FIRE SAFETY FOLLOW UP INSPECTION

Factory Name	A.K.M. KNIT WEAR LTD.		Factory ID	9178
Address	14 No. Genda, Karnopara, Ulail, Savar			
Initial Inspection Date	24-Mar-2014		Report Received Date	
Date of 1st Follow-up	13-Feb-2015	Date of 2nd Follow-up	17-Jan-2016	
Date of 3rd Follow-up	09-May-2016	Date of 4th Follow-up	28-Jul-2016	
Date of 5th Follow-up	16-Nov-2016	Date of 6th Follow-up	24-Jan-2017	
Date of 7th Follow-up	23-Apr-2017	Date of 8th Follow-up	23-Aug-2017	
Date of 9th Follow-up	31-Jan-2018	Date of 10th Follow-up	27-Jun-2018	
Date of 11th Follow-up	17-Feb-2019	Date of 12th Follow-up	05-Sep-2021 and 13-Sep-2021

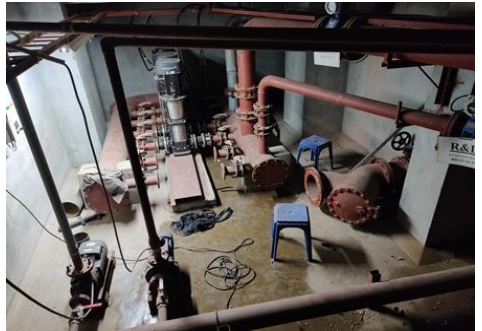
46	Manual on-off switches in several locations are provided for emergency lighting / exit signage units.	Remove manual on/off switches from emergency lighting / exit signage units to prevent them from being switched off.	Within 1 month	<p>On 23/04/2017: Corrected. On 23/08/2017: Corrected On 31/01/2018: Corrected On 27/06/2018: Corrected.</p> <p>On 17/02/2019: Corrected based on previous follow ups.</p>	30-Dec-2014		Corrected	ADD PHOTO
47	Exit sign not provided at the 2nd floor exit.	Provide exit signs above all exits to the exterior and all doors to the exit stairs.	Within 3 months	<p>On 23/04/2017: Corrected. On 23/08/2017: Corrected On 31/01/2018: Corrected On 27/06/2018: Corrected.</p> <p>On 17/02/2019: Corrected based on previous follow ups.</p>	28-Feb-2015		Corrected	ADD PHOTO
